**DRAFT DECISION**

**CitiPower**

**Distribution determination**

**Capital expenditure**

**Figure B.4 AEMO and CitiPower's Forecasts vs AEMO's Weather Corrected Actuals (MW, Non-Coincident, POE10)**

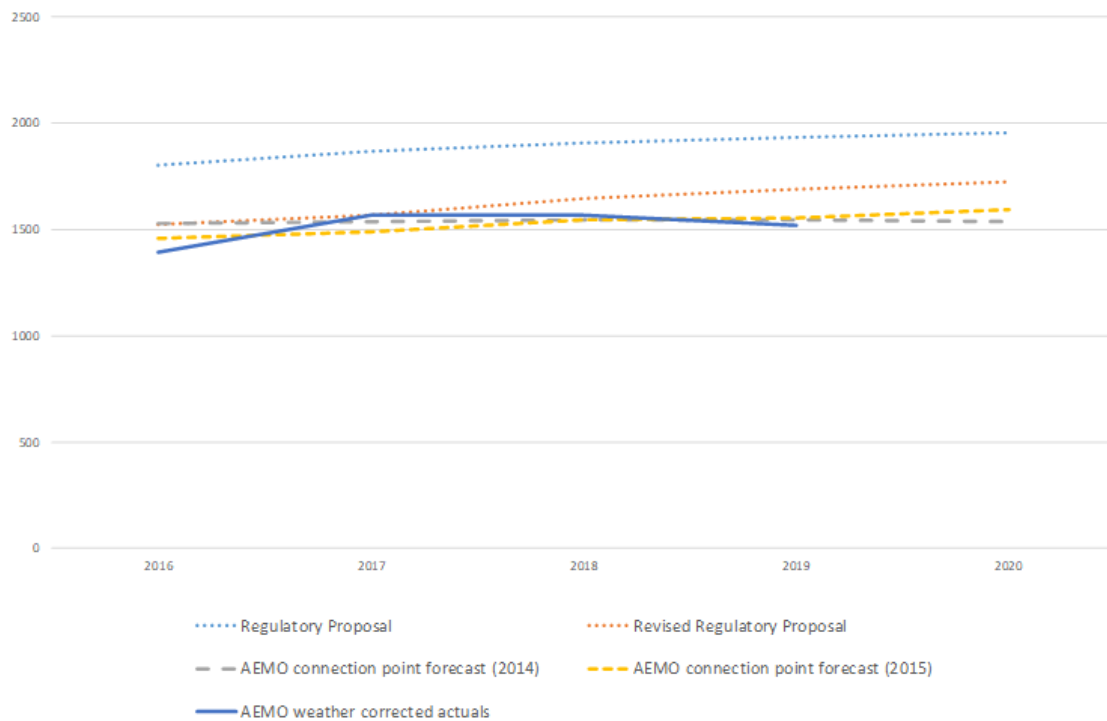
In the previous regulatory control period, CitiPower forecast 2.0 per cent average annual maximum demand growth in its draft proposal, which it increased to 3.1 per cent in its revised proposal. AEMO's 2014 forecasts were for 0.1 per cent average annual growth, which it increased to 2.3 per cent average annual growth in 2014. In percentage terms, CitiPower's forecasts were reasonably accurate when compared with AEMO's weather corrected actuals, which grew at 3.0 per cent per year from 2015–16 to 2018–19. However, the levels diverged significantly. CitiPower's initial and revised proposals exceeded weather corrected actuals by 27.4 per cent and 11.1 per cent respectively. AEMO's, however, were close to weather corrected actuals: the 2014 forecasts were 1.9 per cent higher, and the 2015 forecasts were 2.3 per cent higher as shown in Figure B.4 below.

**Figure B.5 CitiPower's long-term trends of demand per inhabitant for different scenarios (reference year in 2018)**

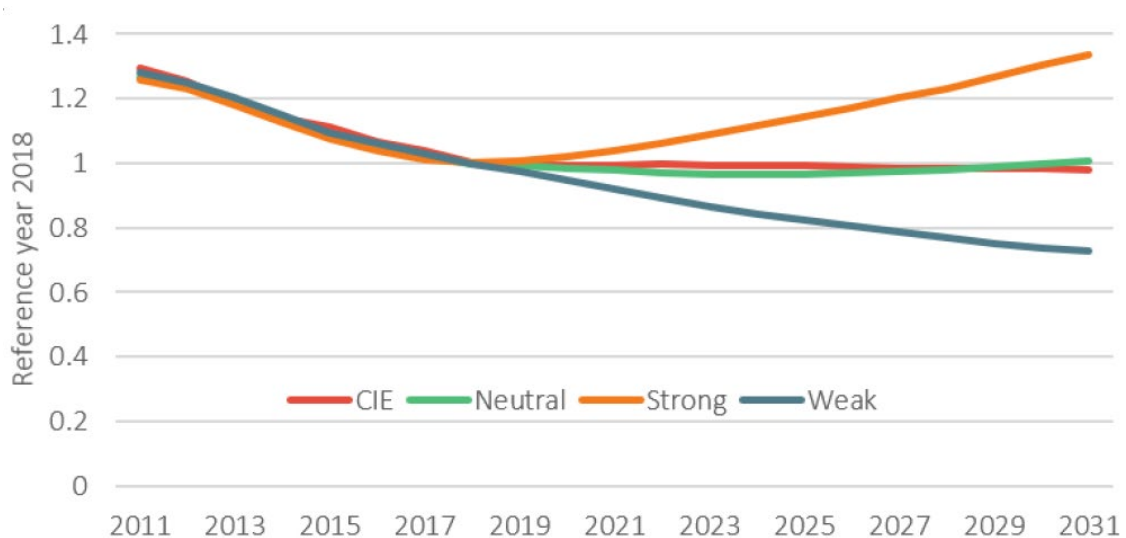
A key output from the modelling is demand by customer. CitiPower provided Figure B.5 below. This highlights how the CIE's forecast is for the historical decline in demand per customer to end relatively rapidly, contrary to historical trends.
